ADDENDUM 1

ITB AP 25-19

VPS Security Checkpoint

Date of Issue: December 27, 2018

AVCON PROJECT NO. 2018.050.04
SHEET NUMBER C-3

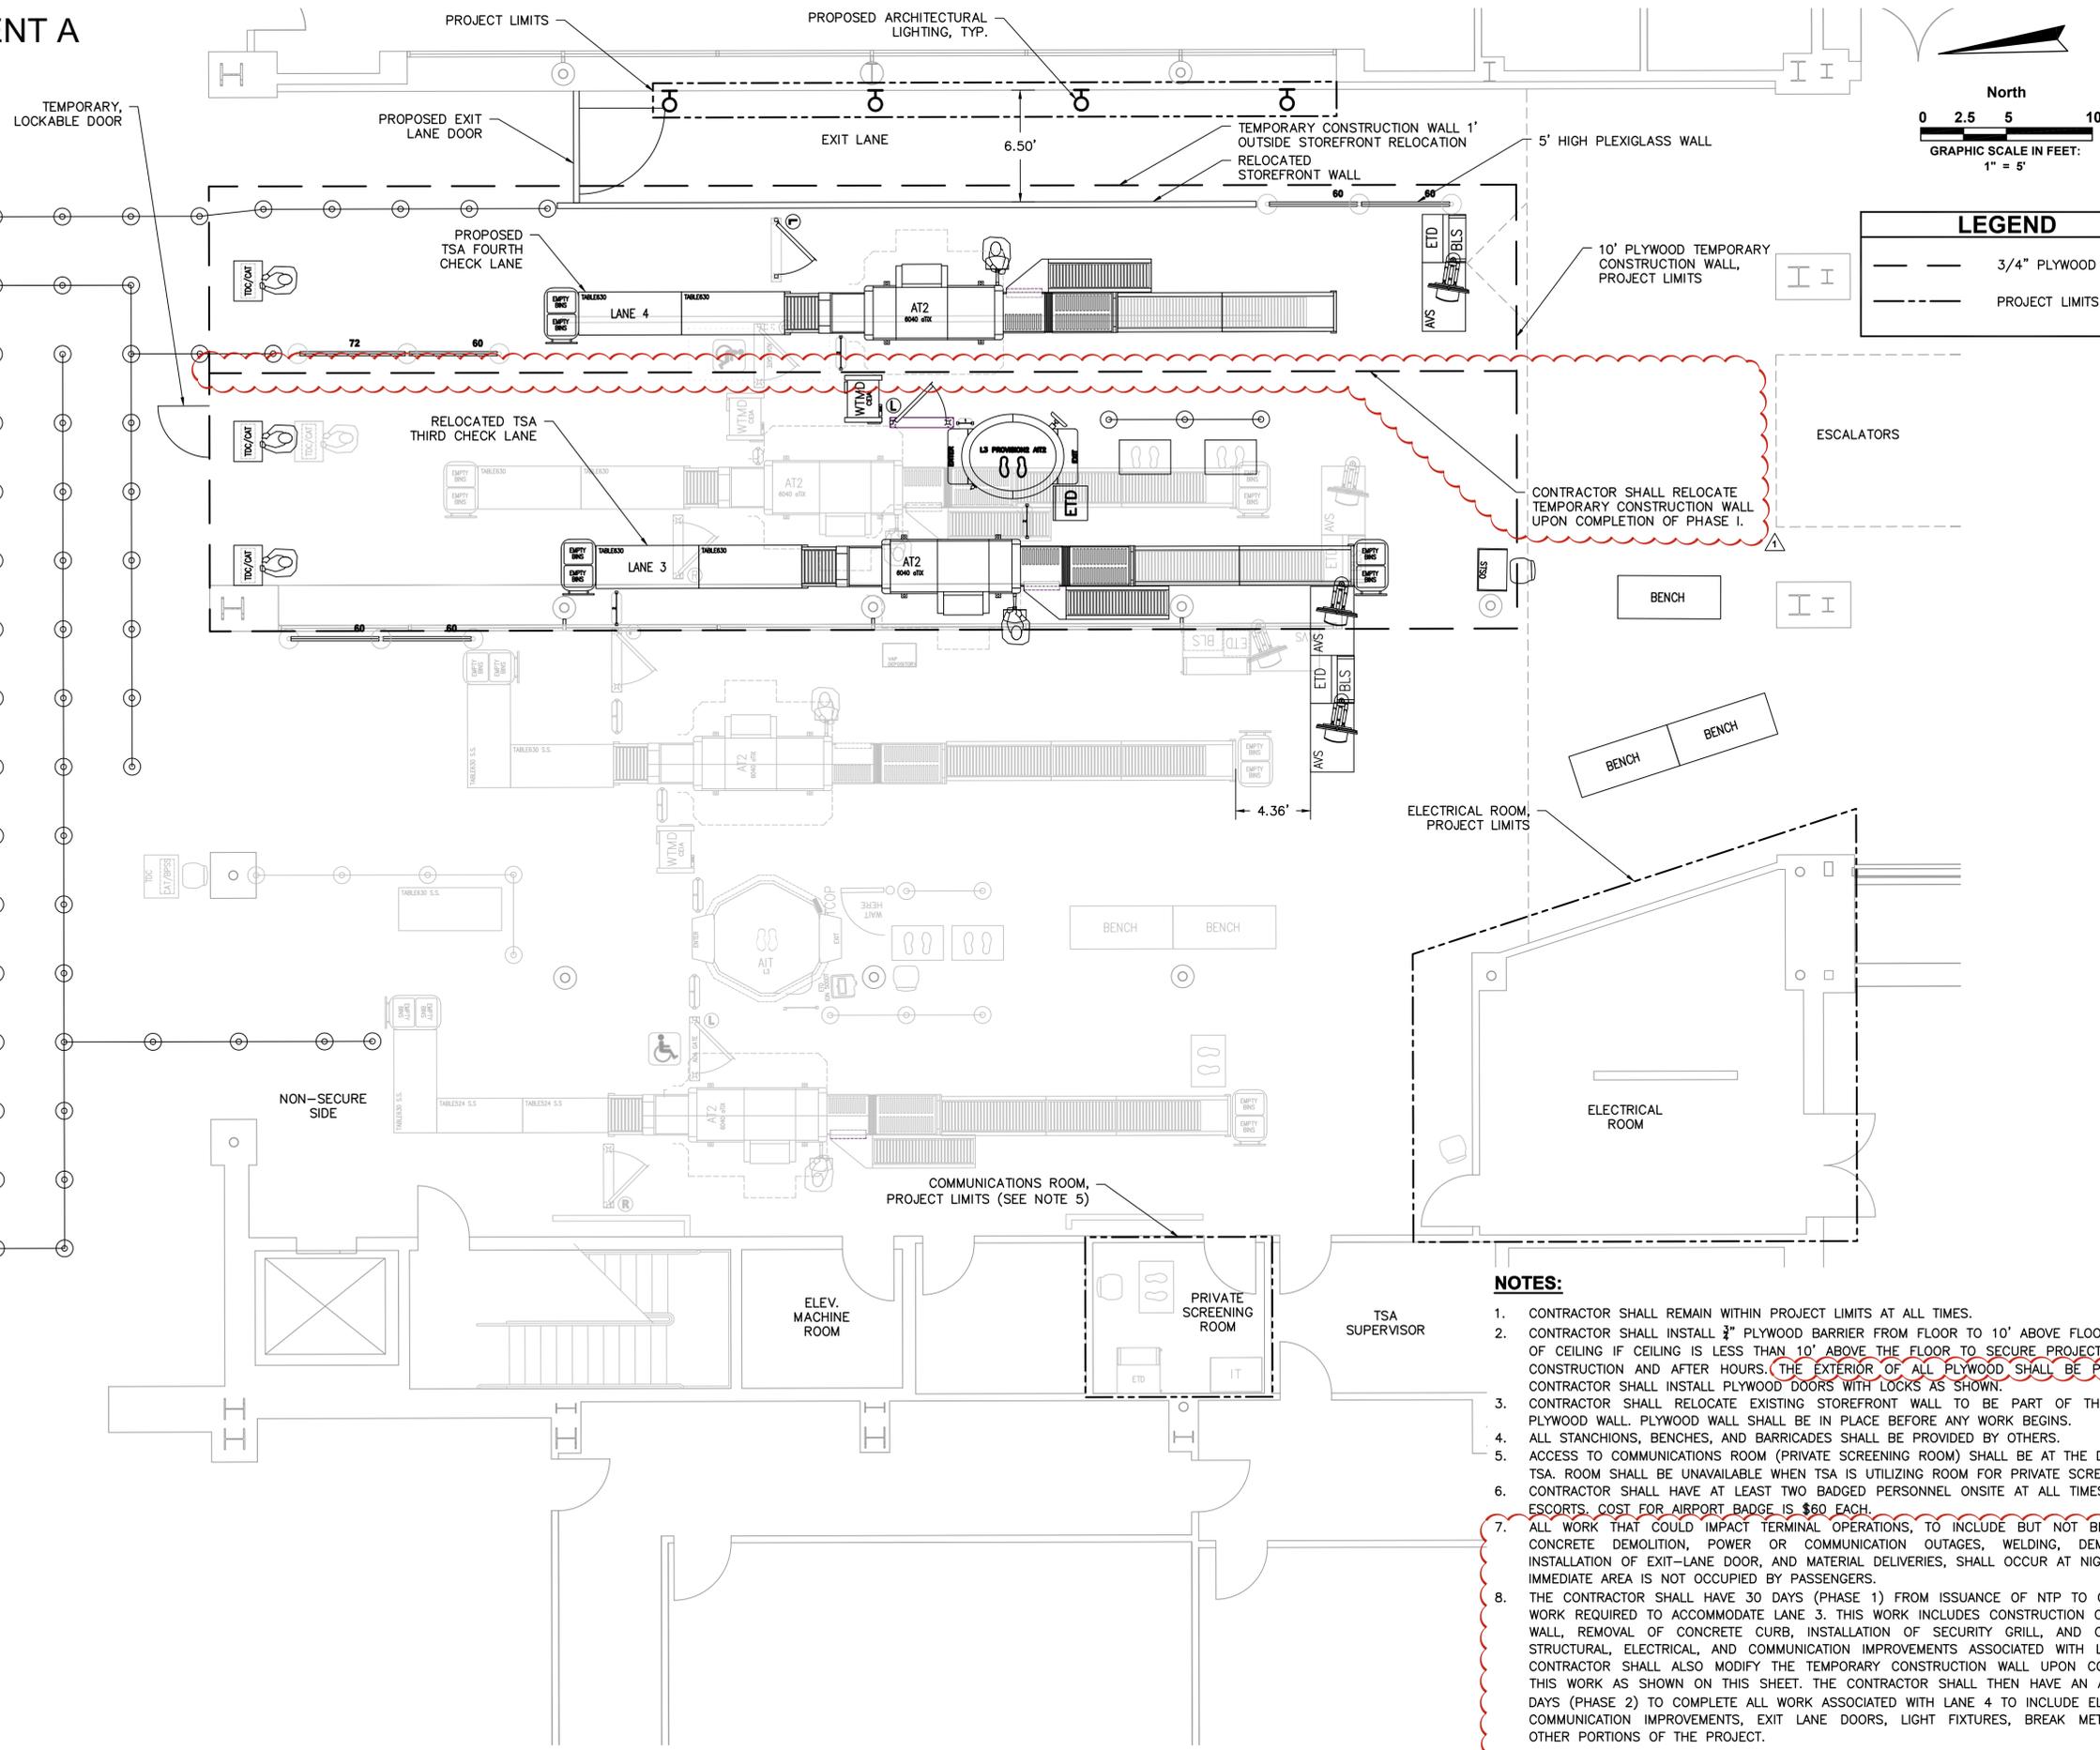
- 1.) Sheet C-3 replacement, Attachment A

- **Discussion Items:** It was discussed that the temporary plywood wall shall be painted white and the door located on the south side of the temporary wall shall be removed. These items will be addressed in Addendum No. 1.

- NOTES:**
- CONTRACTOR SHALL REMAIN WITHIN PROJECT LIMITS AT ALL TIMES.
 - CONTRACTOR SHALL INSTALL 3/4" PLYWOOD BARRIER FROM FLOOR TO 10' ABOVE FLOOR OR BOTTOM OF CEILING IF CEILING IS LESS THAN 10' ABOVE THE FLOOR TO SECURE PROJECT SITE DURING CONSTRUCTION AND AFTER HOURS. THE EXTERIOR OF ALL PLYWOOD SHALL BE PAINTED WHITE. CONTRACTOR SHALL INSTALL PLYWOOD DOORS WITH LOCKS AS SHOWN.

- THE CONTRACTOR SHALL HAVE 30 DAYS (PHASE 1) FROM ISSUANCE OF NTP TO COMPLETE ALL WORK REQUIRED TO ACCOMMODATE LANE 3. THIS WORK INCLUDES CONSTRUCTION OF TEMPORARY WALL, REMOVAL OF CONCRETE CURB, INSTALLATION OF SECURITY GRILL, AND COMPLETE ALL STRUCTURAL, ELECTRICAL, AND COMMUNICATION IMPROVEMENTS ASSOCIATED WITH LANE 3. THE CONTRACTOR SHALL ALSO MODIFY THE TEMPORARY CONSTRUCTION WALL UPON COMPLETION OF THIS WORK AS SHOWN ON THIS SHEET. THE CONTRACTOR SHALL THEN HAVE AN ADDITIONAL 30 DAYS (PHASE 2) TO COMPLETE ALL WORK ASSOCIATED WITH LANE 4 TO INCLUDE ELECTRICAL AND COMMUNICATION IMPROVEMENTS, EXIT LANE DOORS, LIGHT FIXTURES, BREAK METAL, AND ALL OTHER PORTIONS OF THE PROJECT.

10 JAMB DETAIL YKK YES 45FS

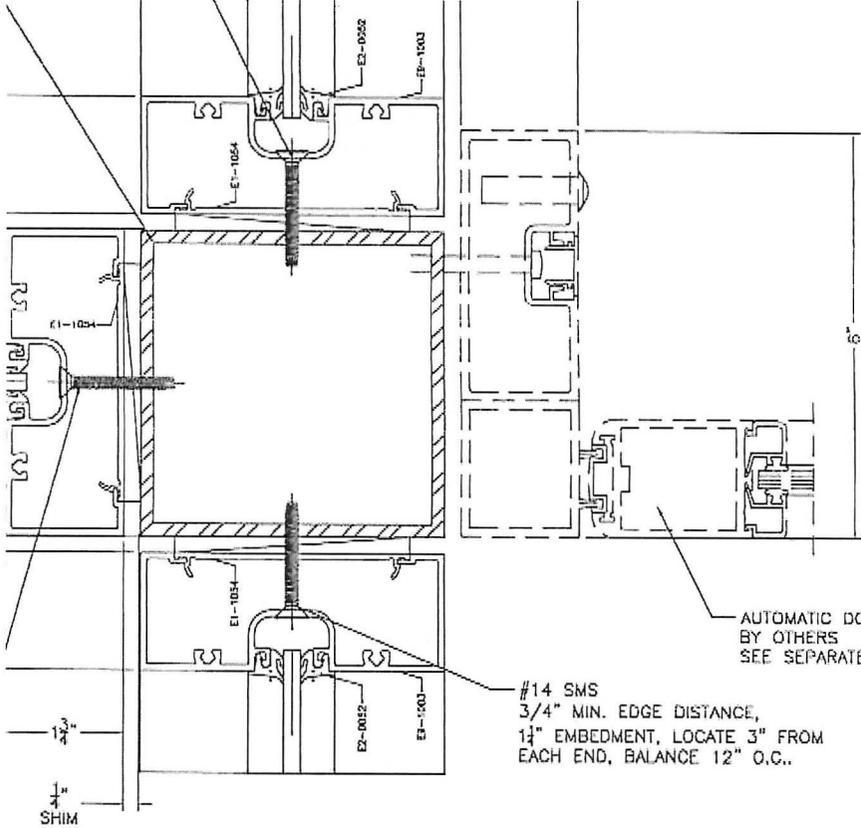
Please identify location of detail.
